ADDENDUM NO. 1

TO: PLANS AND SPECIFICATIONS FOR STATE OF MISSOURI

**Renovate Lobby and Restrooms 1st and 2nd Floor
Howerton State office Building
Jefferson City, Missouri
PROJECT NO.: O2339-01**

6 FIRST FLOOR - RESTROOM RENOVATION PLAN
SCALE: 1/2" = 1'-0"

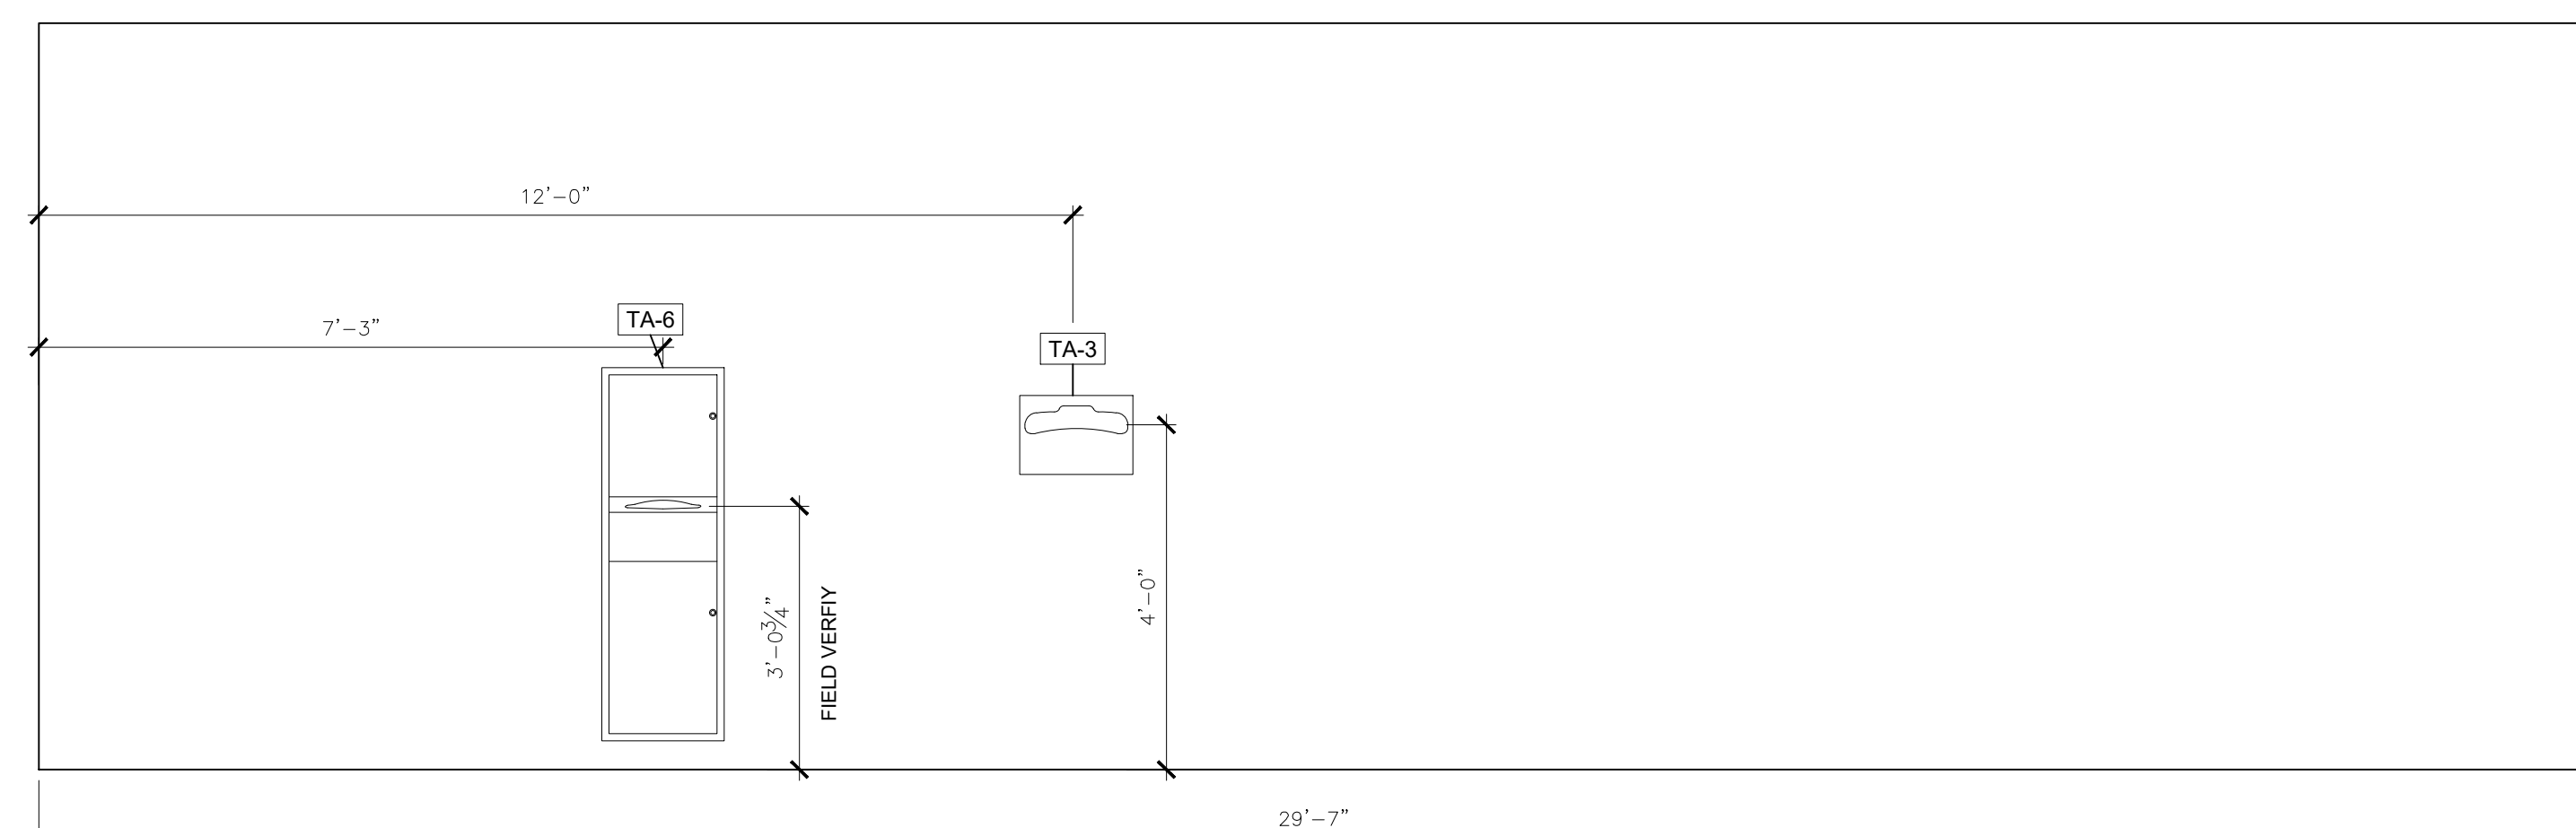
A-201

1. Restroom Finish Schedule: Clarifications per mark.
 - GB-1 Changed grab bar to 36" grab bar.
 - GB-2 Changed grab bar to 42" grab bar.
 - GB-3 Changed grab bar to 18" grab bar.
 - TA-7 Changed coat hook to coat hooks (to be installed inside of stalls)
 - TA-8 Changed mirror to 24" x 72" mirror.
 - TA-9 Changed mirror to 24" x 36" mirror.
2. Changed note from: See A-601 for full fixture schedule to See sheets A-104 - A-105 for full fixture schedules.

A-202

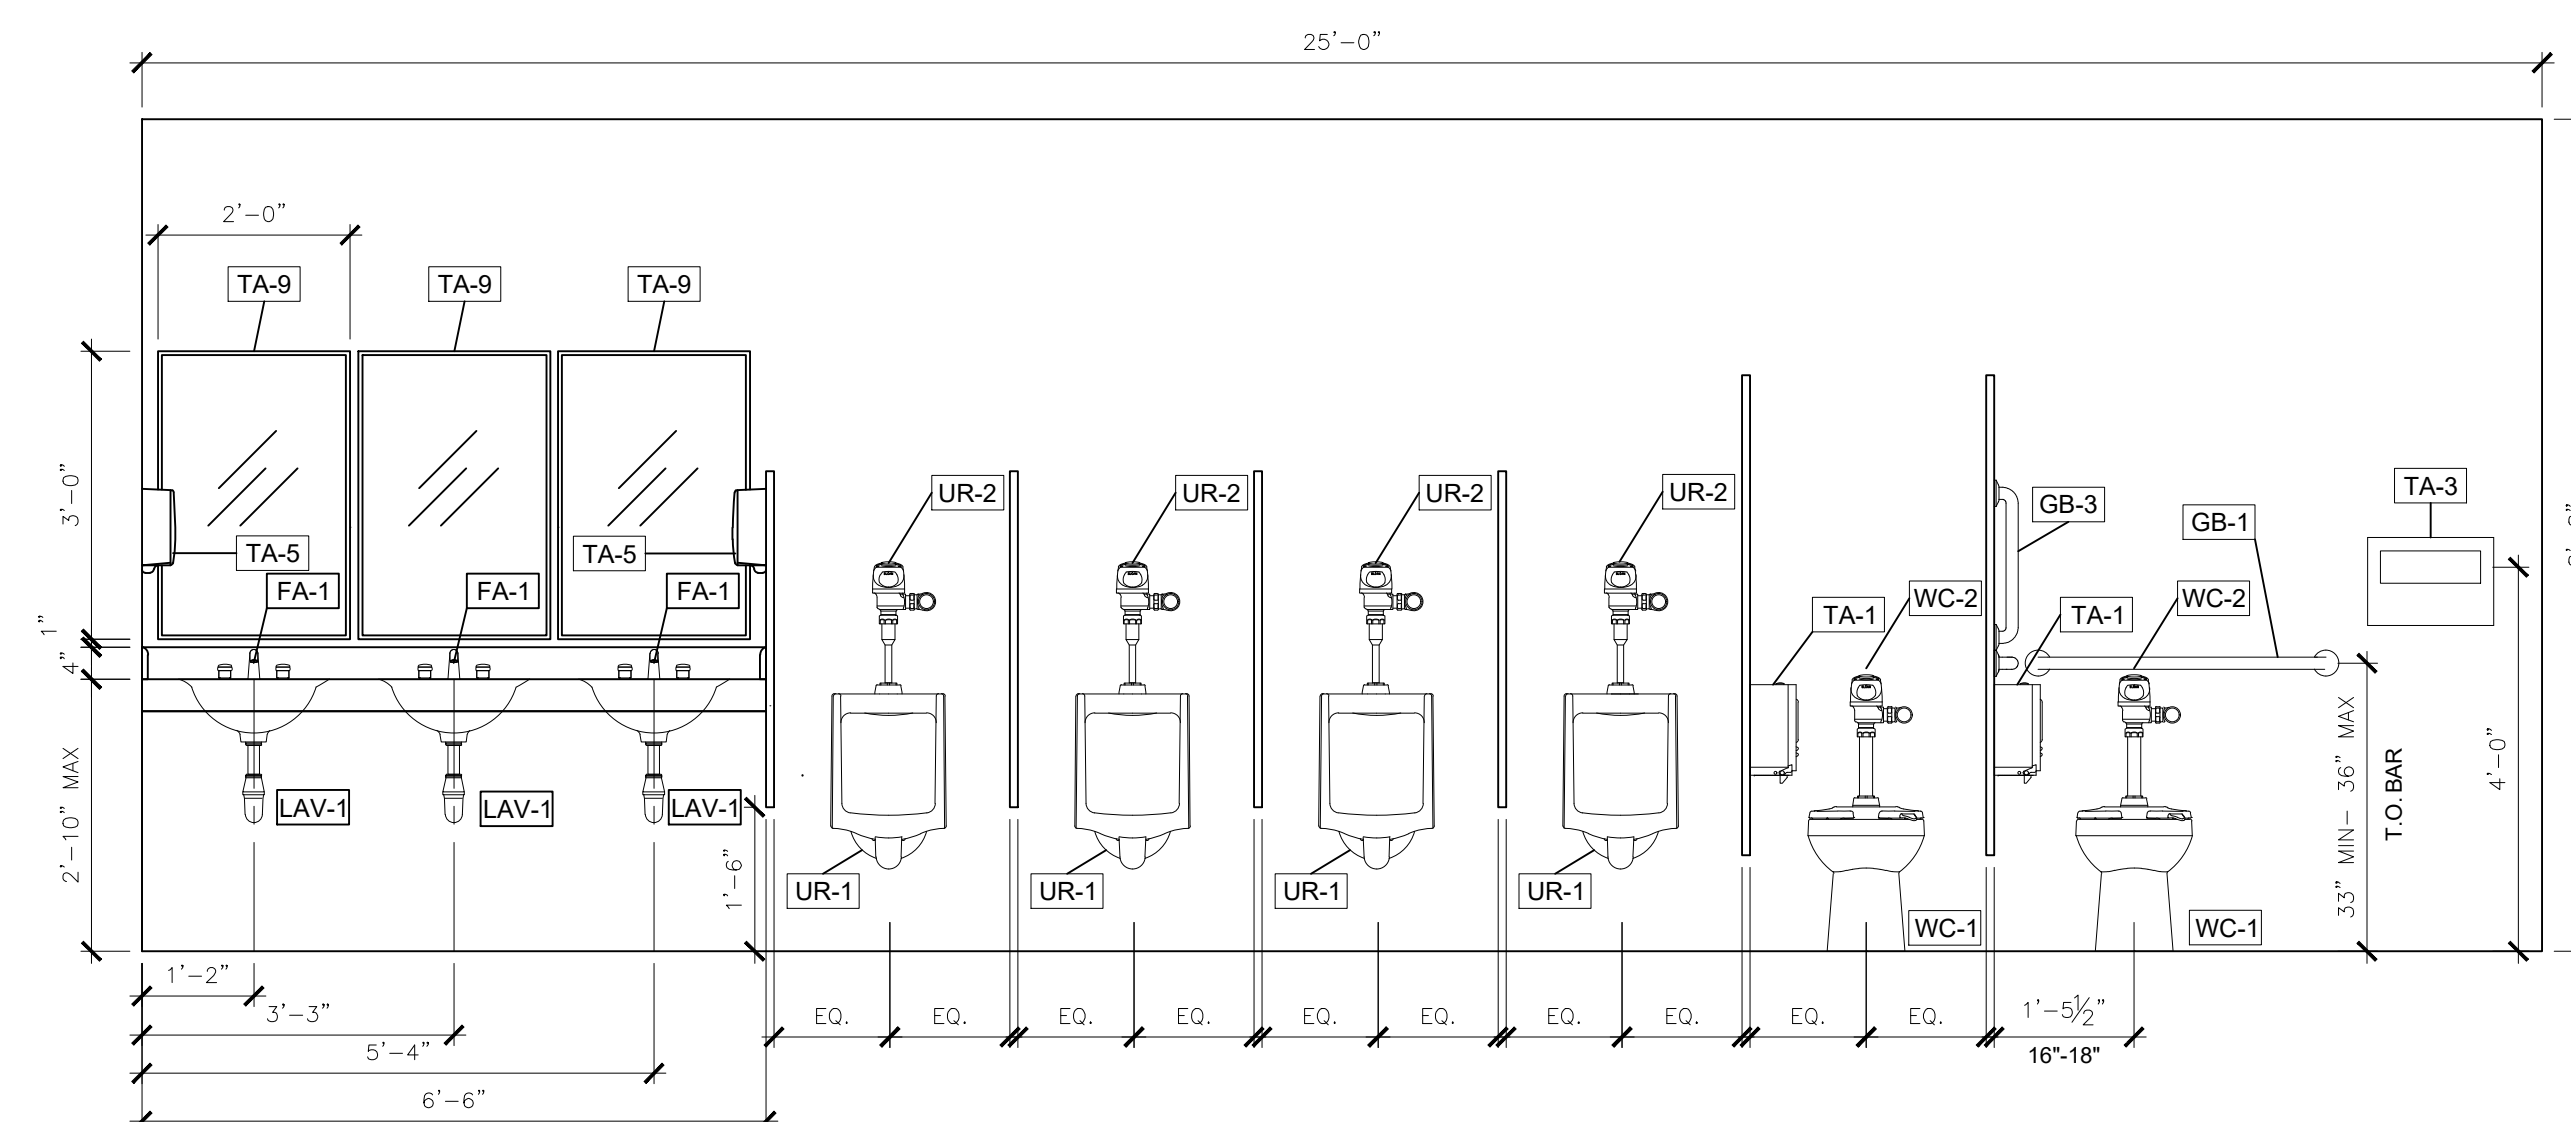
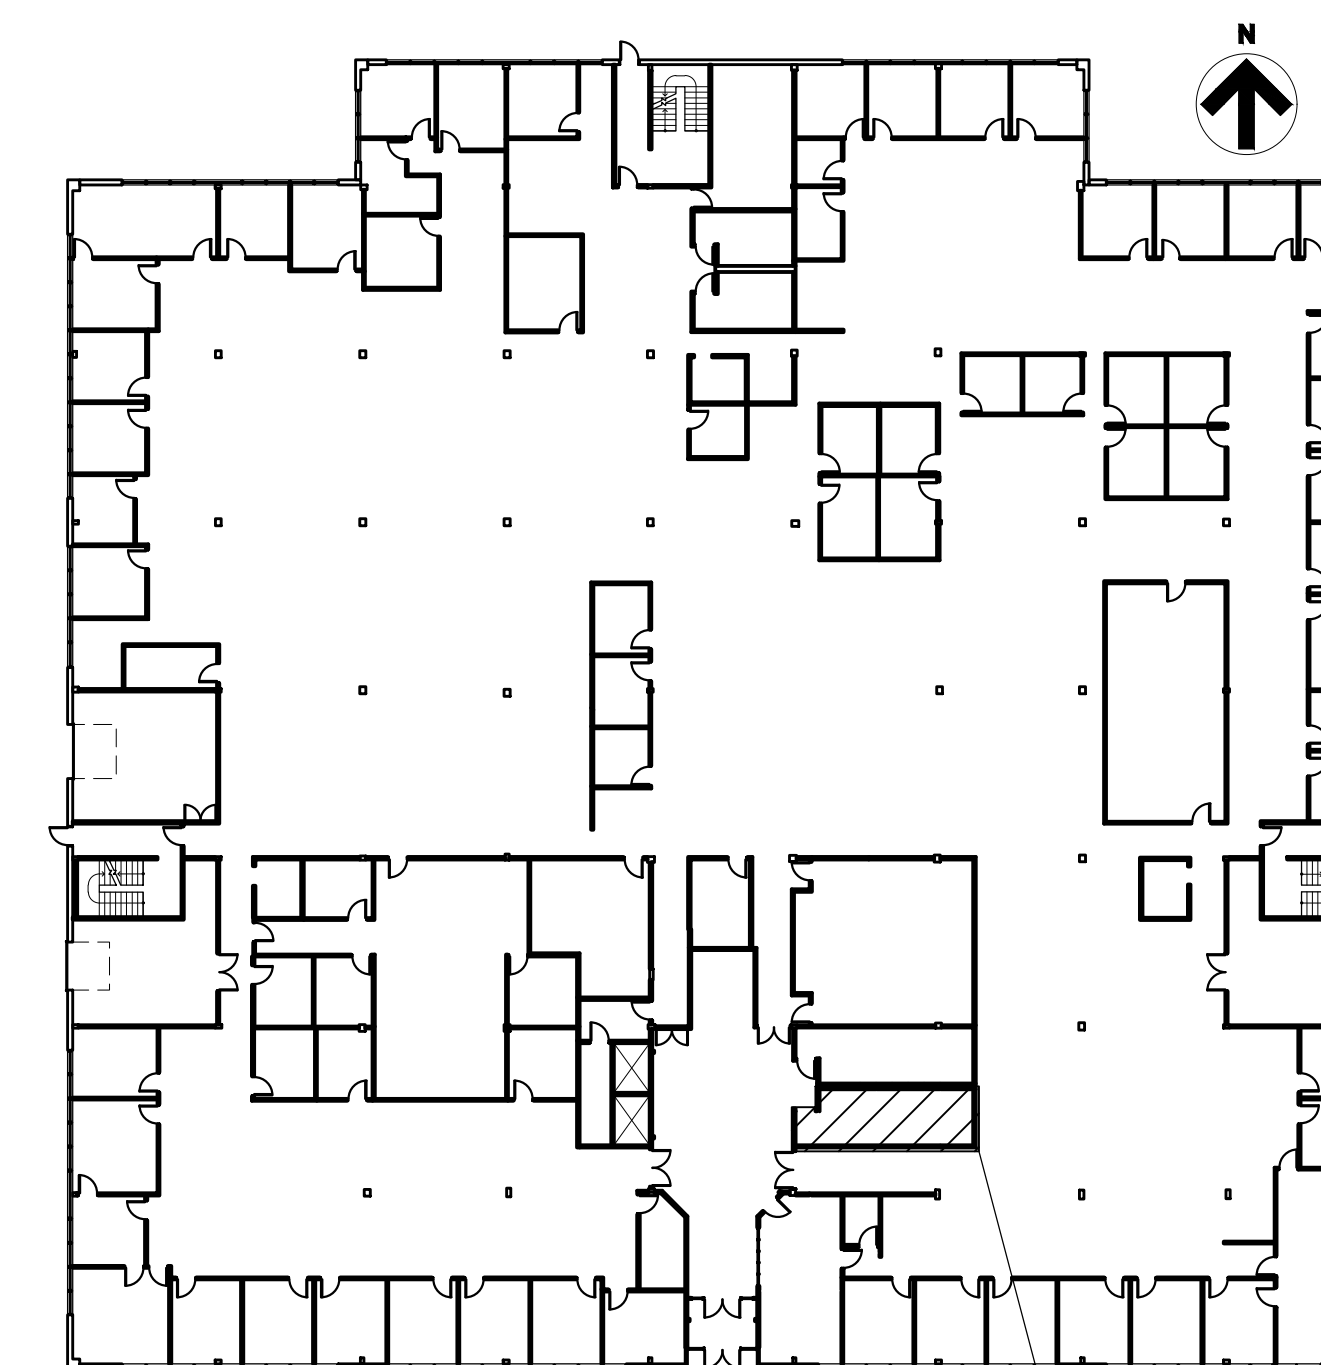
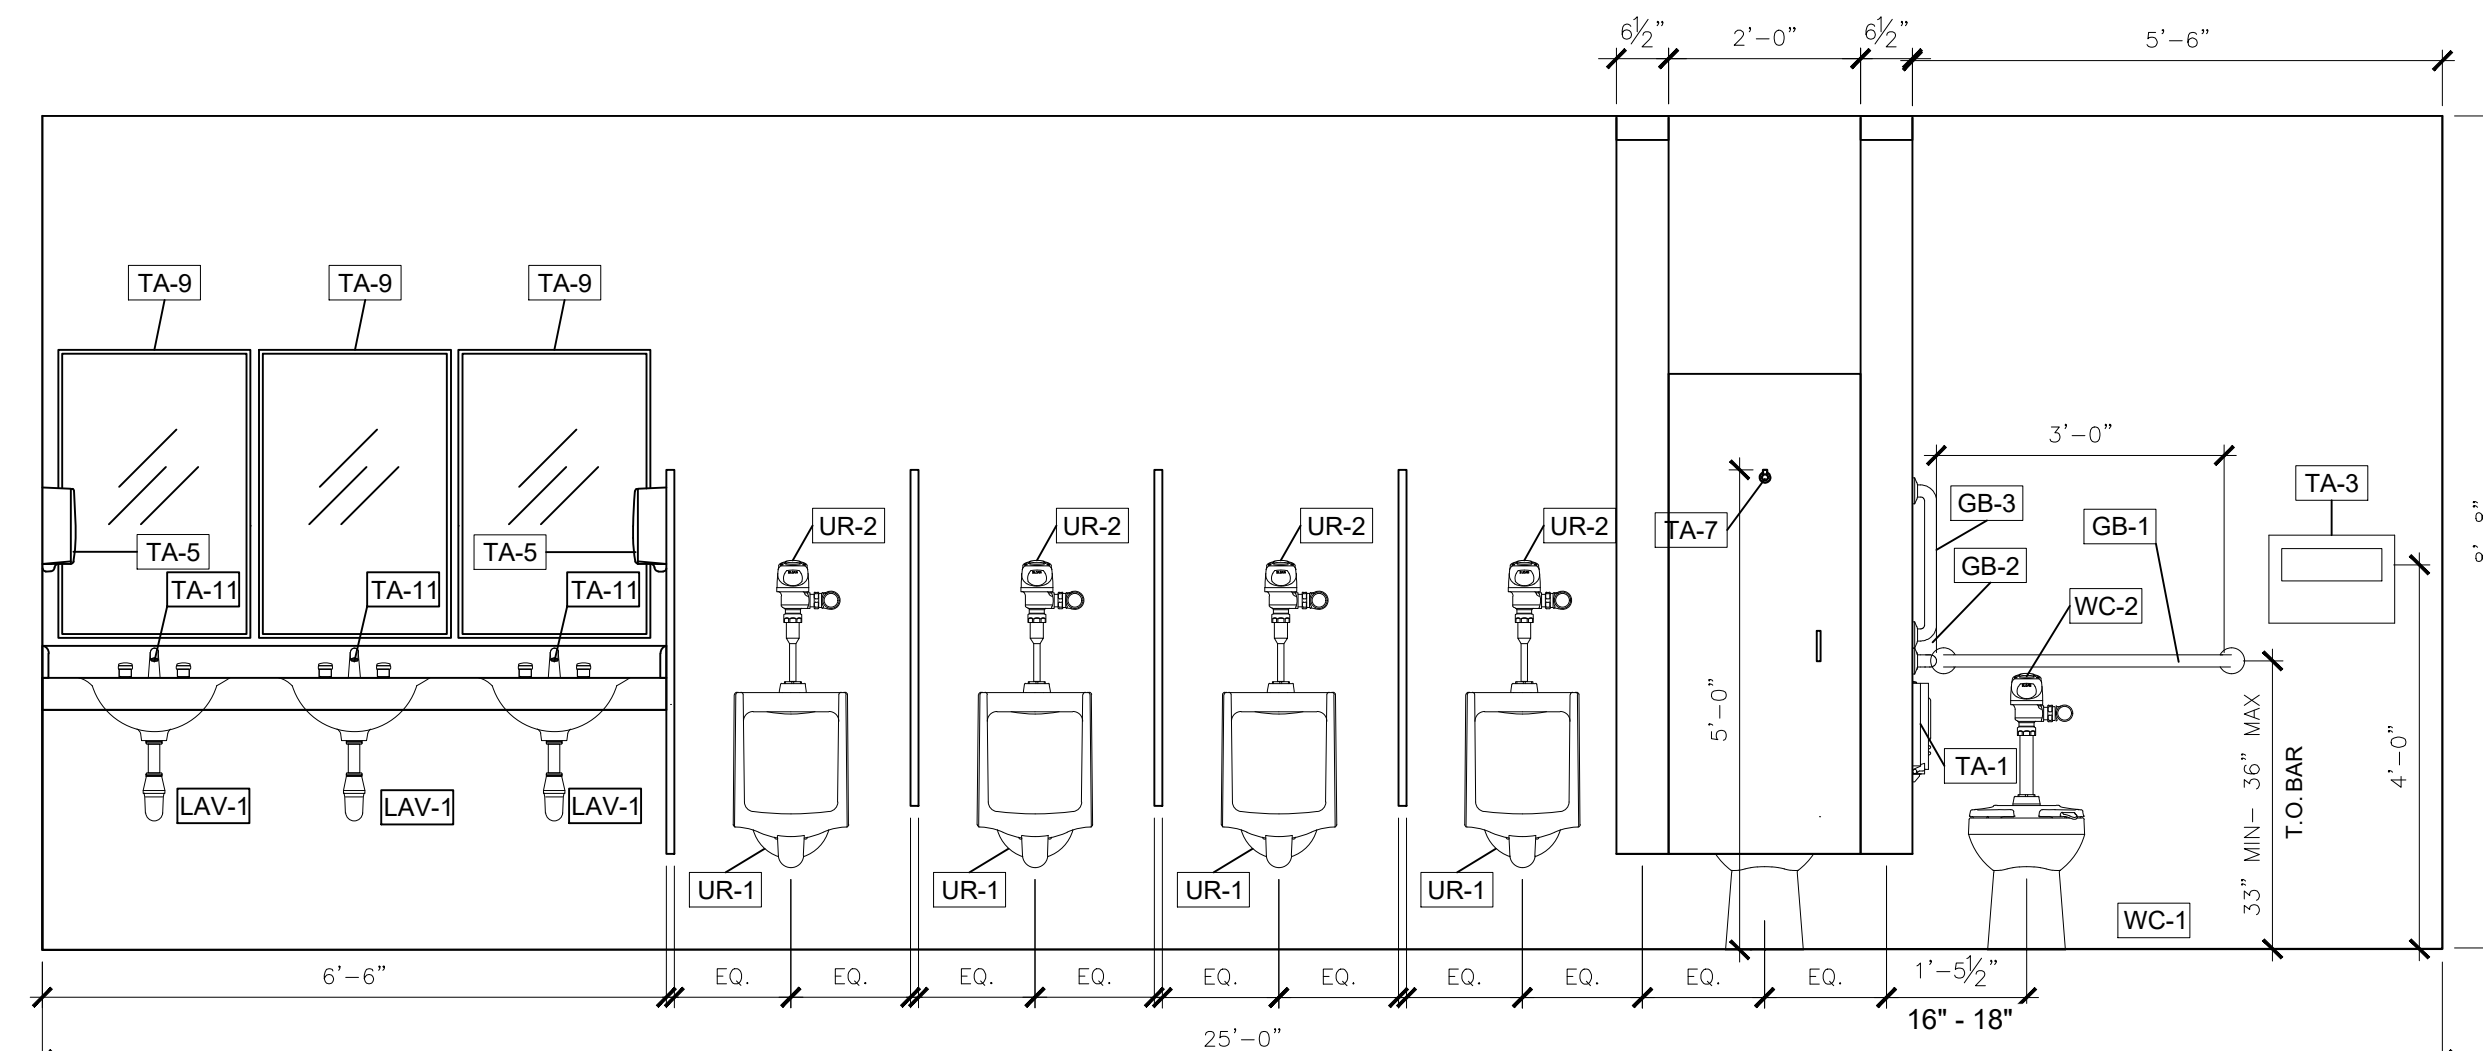
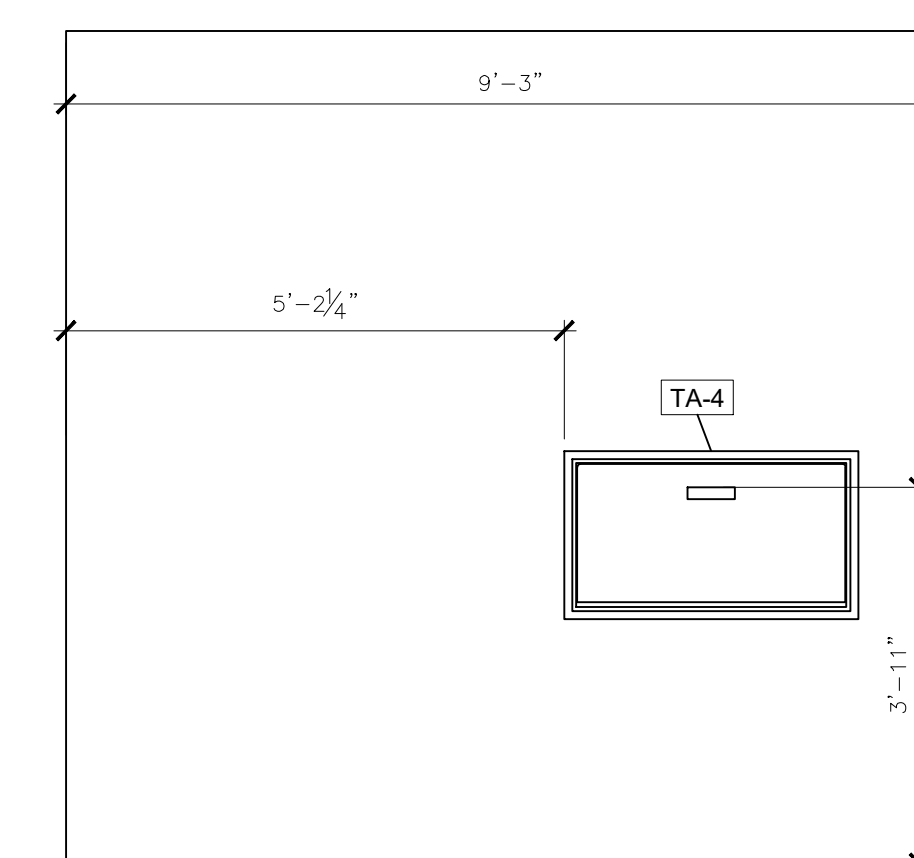
A-202

1. Restroom Finish Schedule: Clarifications per mark.
 - GB-1 Changed grab bar to 36" grab bar.
 - GB-2 Changed grab bar to 42" grab bar.
 - GB-3 Changed grab bar to 18" grab bar.

- TA-7 Changed coat hook to coat hooks (to be installed inside of stalls)
- TA-8 Changed mirror to 24" x 72" mirror.
- TA-9 Changed mirror to 24" x 36" mirror.
- 2. Changed note from: See A-601 for full fixture schedule to See sheets A-104 - A-105 for full fixture schedules.
